PLANNING, ZONING, & BUILDING DEPARTMENT
PZ&B Staff Combination Memorandum: Architectural Commission and Town Council

SUBJECT: ARC-23-165 (ZON-24-008) 161 VIA PALMA (COMBO)

MEETING: DECEMBER 15, 2023 ARCOM
JANUARY 10, 2024 TC

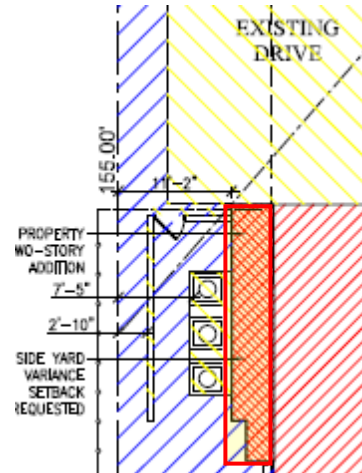
The existing one-story portion is existing nonconforming for side-yard setback at 7.5' in lieu of the 15' required. The new addition will be closer to setback compliance, however, it is still nonconforming at 11.1' in lieu of the 15' required. Thus, the applicant is seeking a side-yard setback variance.

As the diagram to the right illustrates, **Variances 1** occurs at the new two-story addition in the west side yard. In the R-A Estate Zoning District, a minimum 15' side-yard setback is required. While the existing setback is only 7.5' the nonconforming setback is lost with the demolition of the one-story portion. Therefore, the new, two-story portion requires a variance, even though the nonconformity is reduced with a proposed setback of 11.1'.
